Public Comments Fort DuPont Redevelopment and Shore Stabilization Project 2 November 2021

Background: The Fort DuPont Redevelopment and Preservation Corporation submitted an application to DNREC to install slope stabilization revetment along the eastern bank of the Delaware City Branch Channel to the Chesapeake and Delaware Canal. DNREC published a public notice in September 2020, held a virtual Public Hearing in January 2021 and re-published a Public Comment Period in October 2021 and ending 2 November 2021.

Photo 1. In the background is the west end of Fort DuPont's boat ramp complex where the bulkhead meets a rip-rap revetment. This is the area included in the application as Figure 2, Scaled Plan View, near where the heavy, dark line labeled the TC-3 STD encompasses the north end of the worksite.

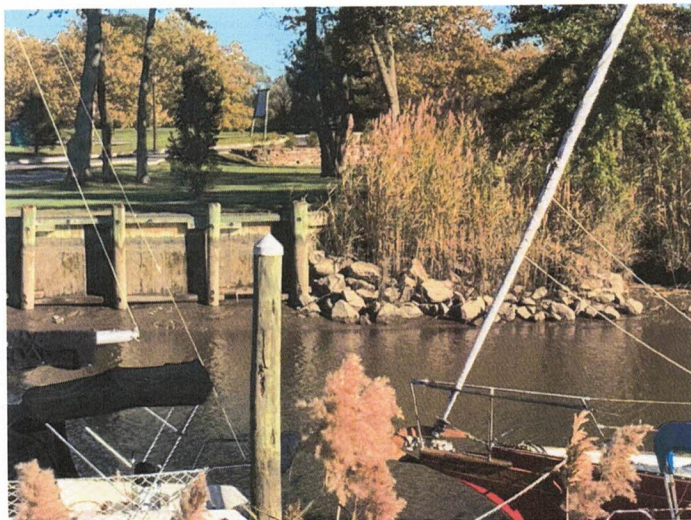
If photos had been submitted as part of the permit application and Appendix I, Line 1 accurately answered, those who review the application would be able to see portions of earlier, much older construction in the area to be destroyed by this slope stabilization project.

Below are some scenes from the Delaware City Branch Channel of the area to be removed and stabilized by this permit. At no point has any organization or office reviewed these remnants to determine their historical significance. If this permit is approved, these historic parts of the original Chesapeake and Delaware Canal will be destroyed forever. To date, almost \$20MM of taxpayer money has been used by the Fort Corp; a majority of which has been spent to save historic structures. It is reported that the oldest of these rehabbed structures date to 1898 and none of the structures rise to more than historic architecture. Yet the last vestiges of the original Chesapeake and Delaware Canal, a canal from 1829 that provided for the growth of the nation is placed on the developer's chopping block and the remnants of national historic significance lost forever.

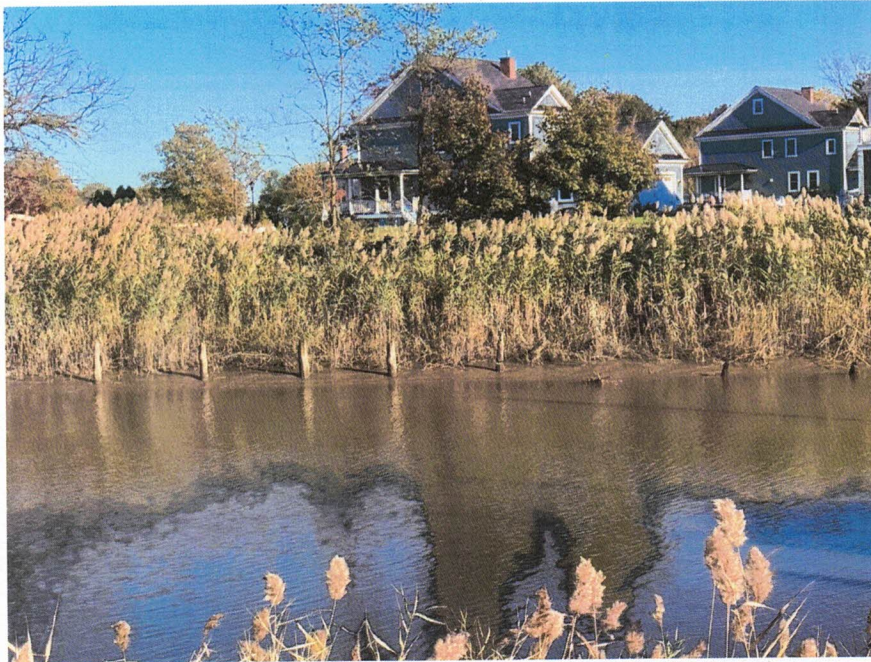
Photo 2. Seen in front of the phragmites are existing old piles of previous construction of the Chesapeake and Delaware Canal. This area is within the slope stabilization work site. The locations of these piles are faint and difficult to see on the Scaled Plan View of the application. The piles are shown in the background of the contour lines on the Scaled Plan Views.

Photo 4. Rubble remnants are visible along the length of the shoreline. Seen are concrete steps.

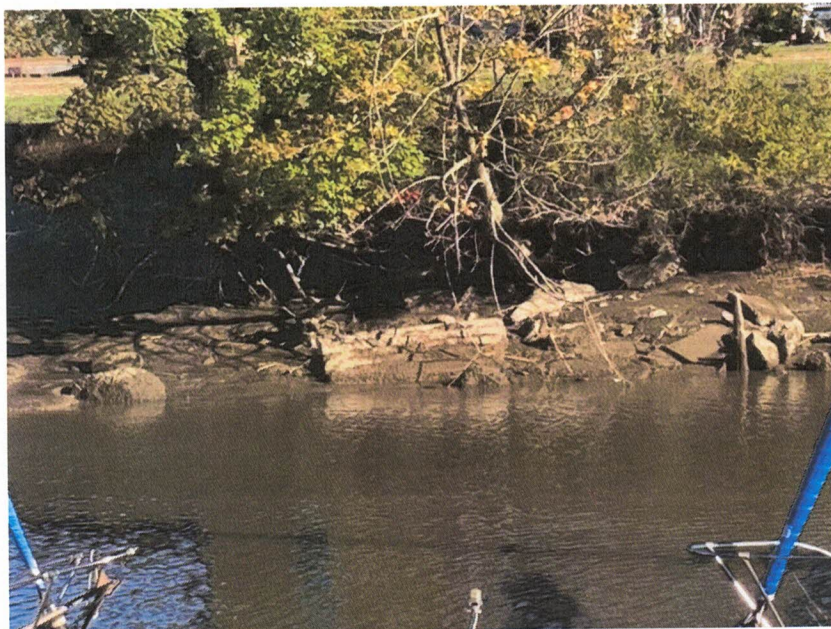
To date, this application process has been devoid of any historic review. There has been no Section 106 Review Process. The altering of the shoreline and destruction of these artifacts is premature without a Section 106 Review Process. The Fort DuPont Redevelopment and PRESERVATION Corporation should attempt to live by its name and request a Section 106 Review Process before any permit application is accepted by the state or USACE.
